Support for CWM removal

Jeff Slavick

Conclusion – why remove CWMs from 25GE

Draft edits

Figure 108-2 Functional Block Diagram

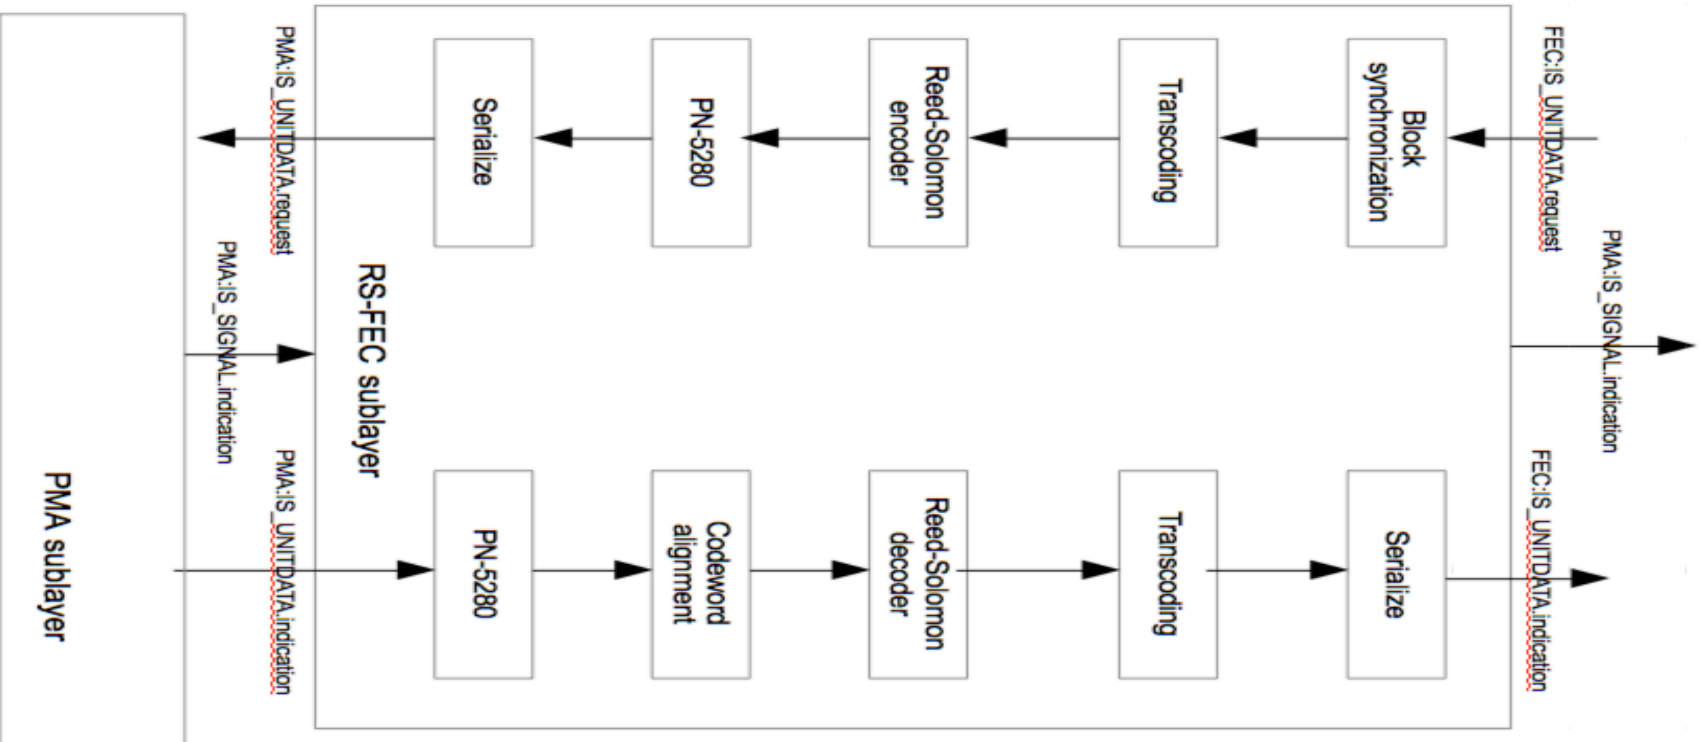
- **Following slides show the edits necessary to remove CWM from the D1.0 as the RS-FEC codeword lock mechanism and to implement deep sleep EEE operation without CWMs.**

Edits to D1.0 inline

Figure 108-3 Transmit bit ordering

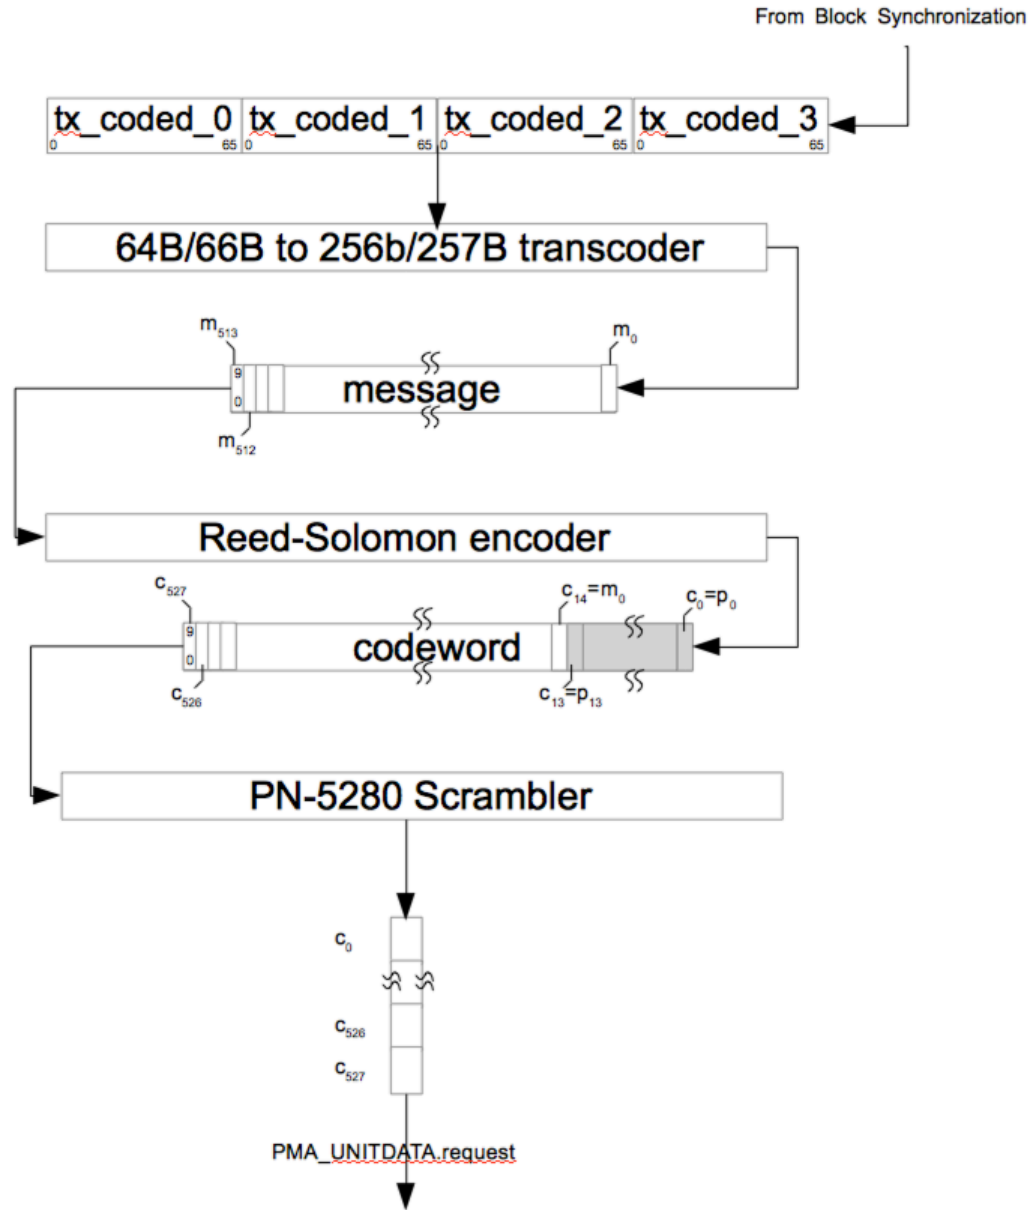
108.5.2.6 Codeword serialization

Once the data has been Reed-Solomon encoded and scrambled by the PN-5280, it shall be serialized and sent to the PMA using the PMA:IS_UNITDATA.request primitive with the transmit bit ordering illustrated in Figure 108–3.

Figure 108-5 FEC synchronization state diagram

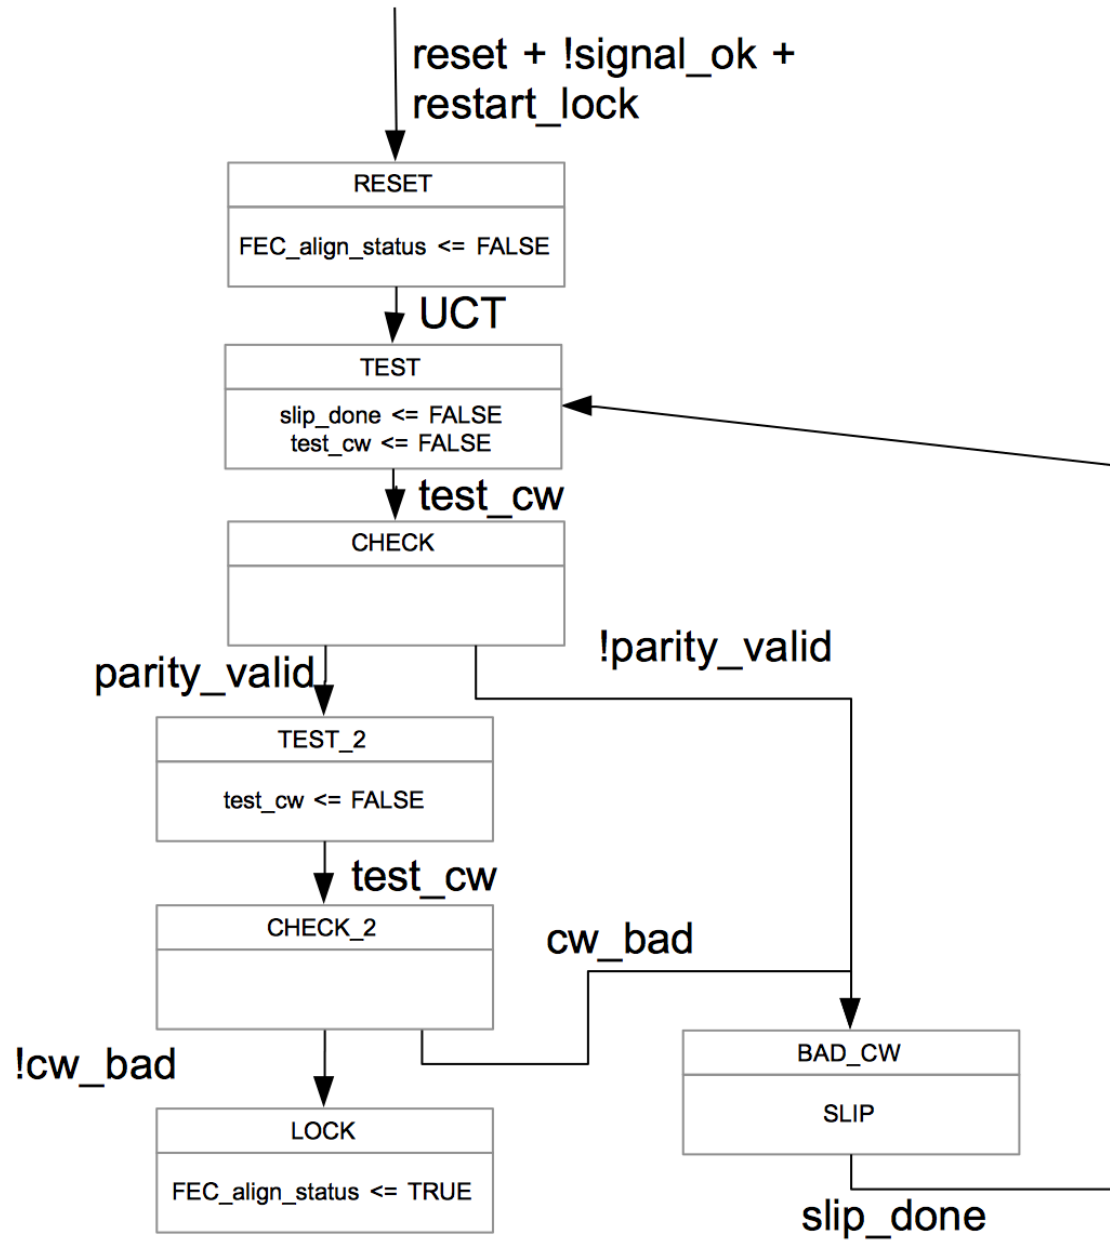
test_cwm

Boolean variable that is set to true when a candidate block position is available for testing, and is set to false according to the FEC synchronization state diagram in Figure 108-5.

test_cw

Boolean variable that is set to true when a new FEC codeword is available for decoding and is set to false according to the `codeword_monitor` state diagrams in Figure 108-5 and Figure 108-6.

- **Delete 108.5.2.2, 108.5.2.4, 108.5.2.4, 108.5.3.6**
- **Remove total of 7 instances of “marker(s)” in 108.5.3.1 and 108.5.3.3**
- **Delete** “rx_coded_0<1:0> corresponding to the second 257-bit block and” **from 108.5.3.2**
- **Delete variables: cwm_counter_done, cwm_valid, test_cwm, cwm_counter, scrambler_bypass, descrambler_bypass**
- **Replace figures 108-2,3,4,5 with versions from slides 9-21**
- **Add “and scrambled by the PN-5280” after “encoded” in 108.5.2.6**
- **Add “and descrambling them with a PN-5280 generator.” after “they are received” in 108.5.3.1**
- **Add definition for PN-5280 pseudo noise sequence generator between 108.5.2.5 and 108.5.2.6 (see slide 24)**
- **Add definition for parity_valid to 108.5.2.4 (see slide 24)**
- **Update definition for test_cw (see slide 24) (additional Figure reference)**

test_cw

Boolean variable that is set to true when a new FEC codeword is available for decoding and is set to false according to the state diagrams in Figure 108-5 and Figure 108-6.
